Re: 1200 Stagecoach

Request for Certificate of Occupancy - Permanent

Hydrology Final Inspection – Approved

Re: Engineer's Certification – 1200 Stagecoach Rd SE - M23/D021

GRADING AND DRAINAGE PLAN ELLIOTT RESIDENCE GARAGE 1200 STAGECOACH RD SE, ALBUQUERQUE, NM

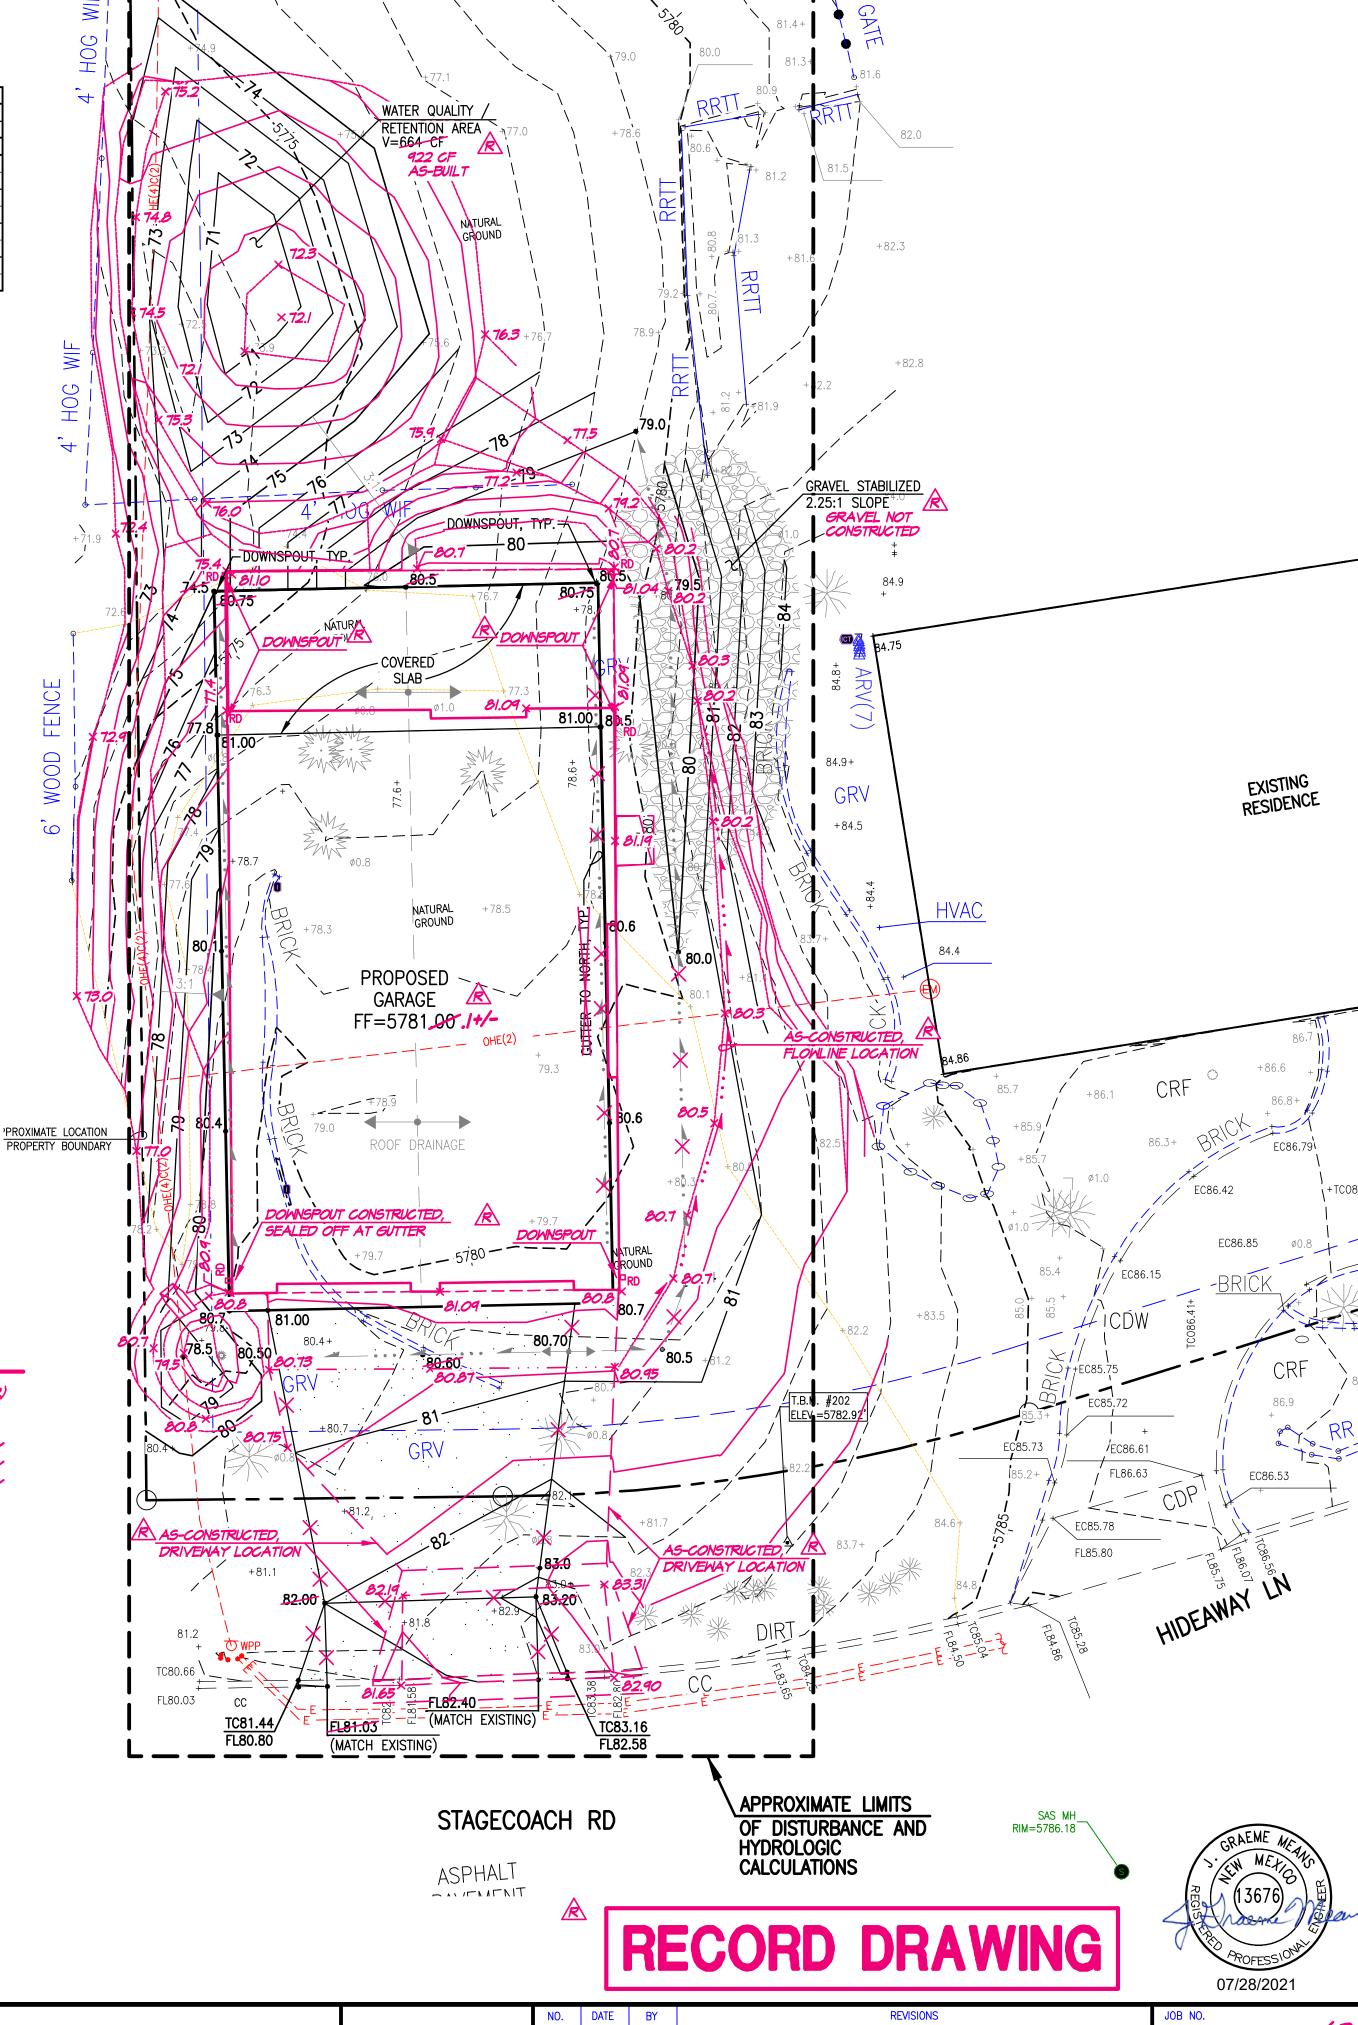
As noted on the attached as-built plan, the following deviations from the approved plan that do not preclude certification were noted:

- 1) The northern stormwater quality pond was not graded in close conformance to the design, but will still accept the intended runoff and has much greater capacity than required.

- 2) The drivepad geometry varies from the design, but does not impact the intended drainage patterns.
- 3) The flowline around the east side of the garage was constructed farther to the east than designed, but still functions as intended to route runoff around to the north and to the pond.

- 4) The gravel slope stabilization near the northeast side of the garage was not constructed, but this will not impact the public. Although the Owner may experience erosion, any sediment will end up in the much larger retention pond.

- 5) The gutters were constructed with additional downspouts at the SW and SE corners. The one at the SE corner is not problematic as the discharge goes to the flowline on the east side of the garage and to the retention pond. The downspout at the SW corner was problematic with respect to plan intent as it would discharge to the adjacent home. After my initial site visit, I alerted the Owner and he had his contractor comer back to seal off the opening at the gutter, thereby sending the runoff to the north as intended.

Based on the submittal received 8/17/2022 and inspection on 8/18/222 in addition to the addressed

concern noted via email on 8/29/2022 this certification is approved for Permanent Certificate of

Occupancy by Hydrology.
